ADDENDUM NO. 4
TO THE CONTRACT DOCUMENTS

Date: July 2, 2018
Project No.: 682450

Pump Stations Rehabilitation Phase 1 H, B, And A Generator

City of Key West, Key West, Florida

SITE PLAN PUMP STATION B
NTS

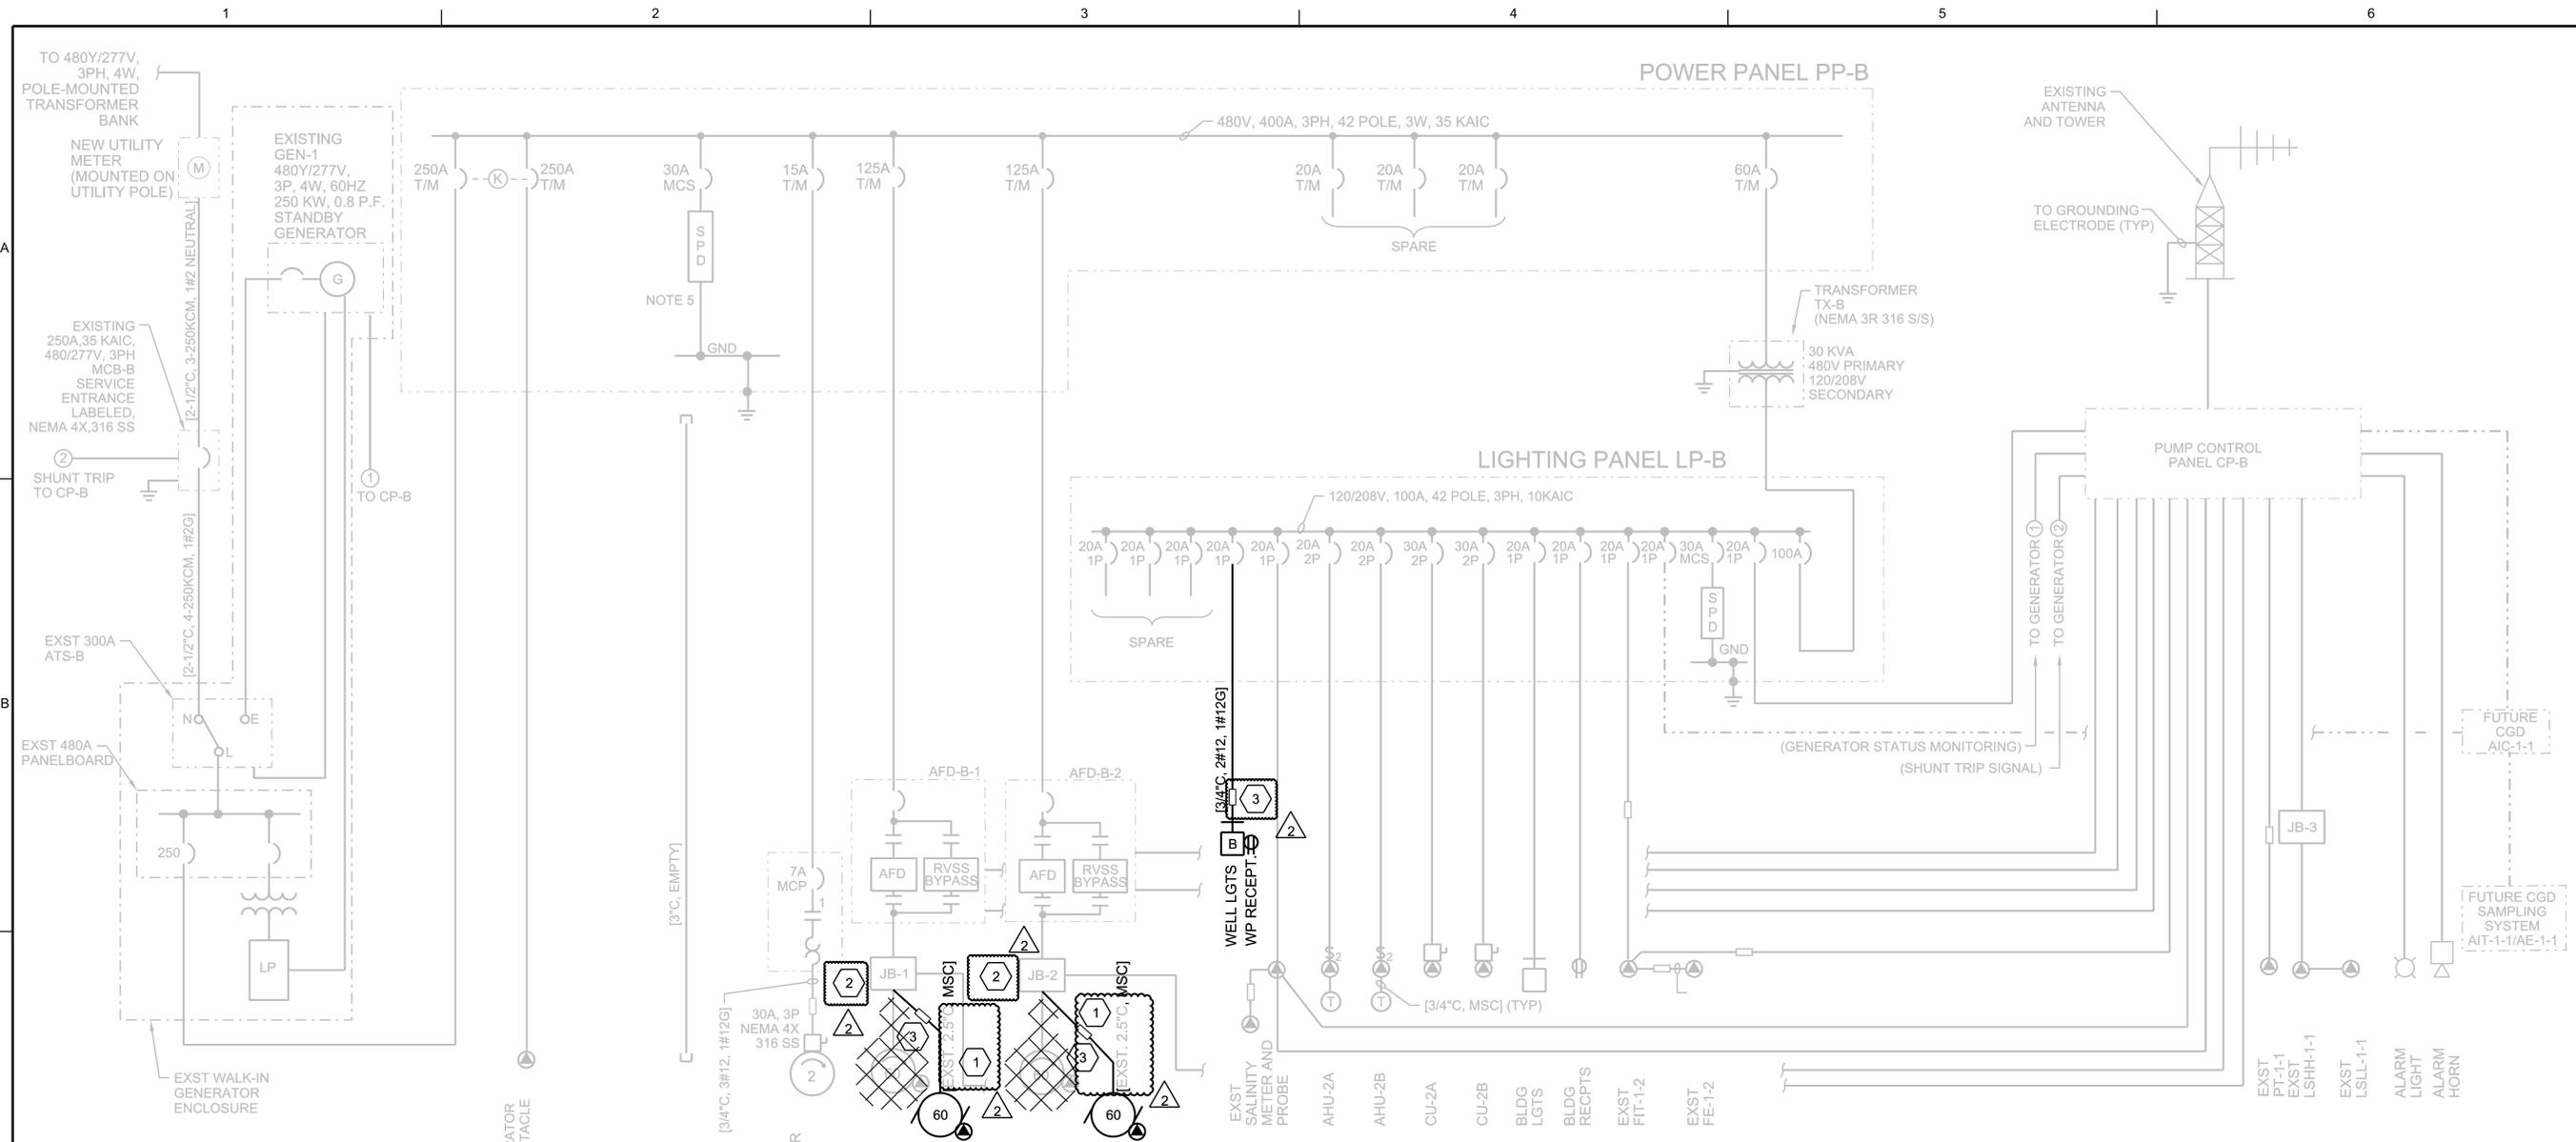
4. Drawing 010-E-201, Electrical Pump Station B Site Plan: DELETE the following Drawing and REPLACE with the attached.
5. Drawing 010-E-601, Electrical Pump Station B One Line Diagram: DELETE the following Drawing and REPLACE with the attached.

REVISED ONE LINE DIAGRAM

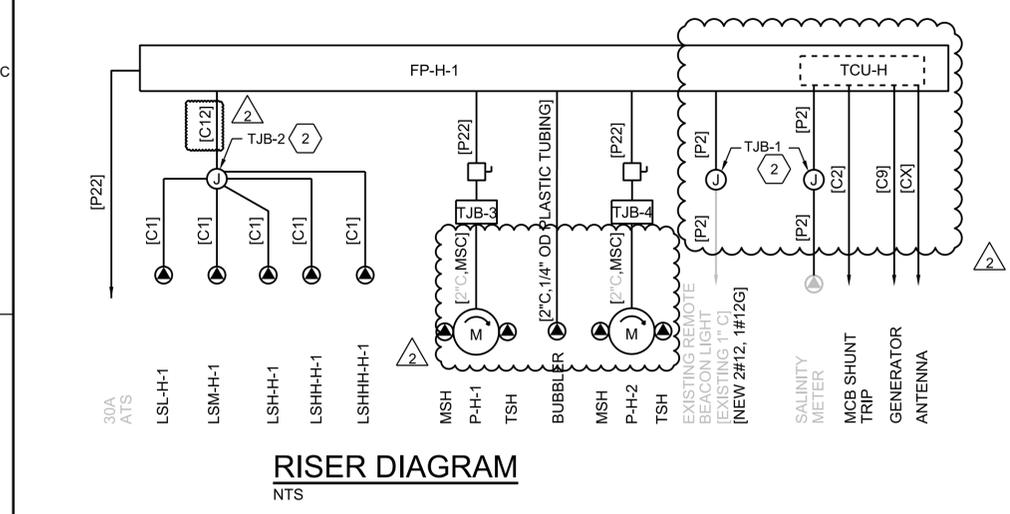
10. Drawing 020-E-601, Electrical Pump Station H One-Line Diagram: DELETE the following Drawing and REPLACE with the attached.
11. Drawing 030-S-201, Structural Pump Station A Platform A Plan And Section: DELETE the following Drawing and REPLACE with the attached.

RISER DIAGRAM
 PUMP STATION A

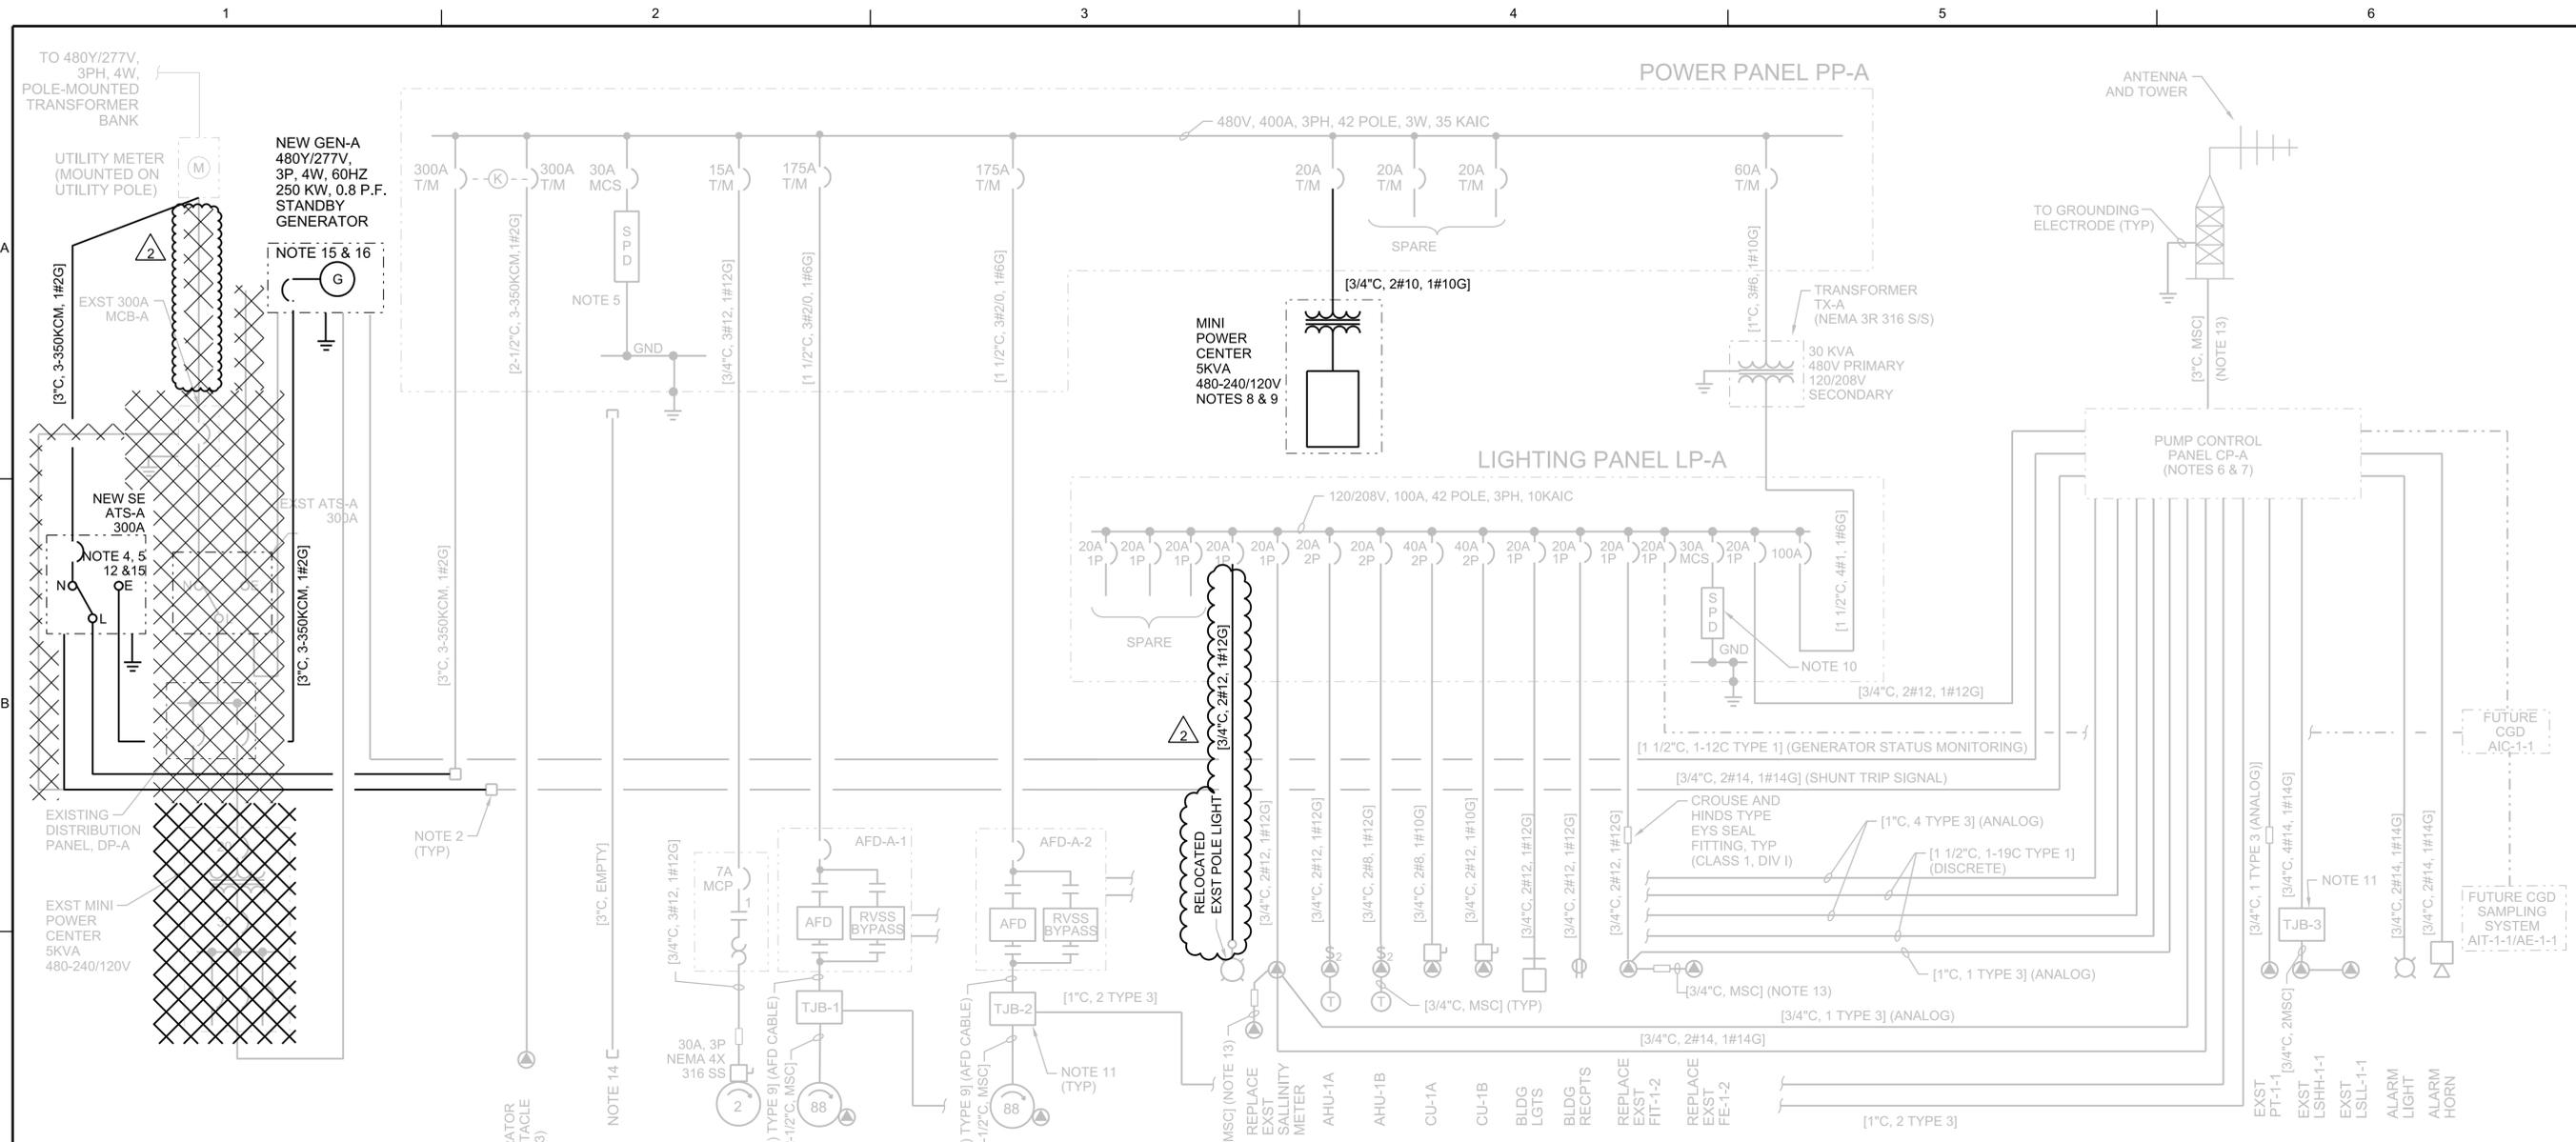
12. Drawing 030-E-201, Electrical Pump Station A Site Plan: DELETE the following Drawing and REPLACE with the attached.
13. Drawing 030-E-202, Electrical Pump Station A One Line Diagram: DELETE the following Drawing and REPLACE with the attached.
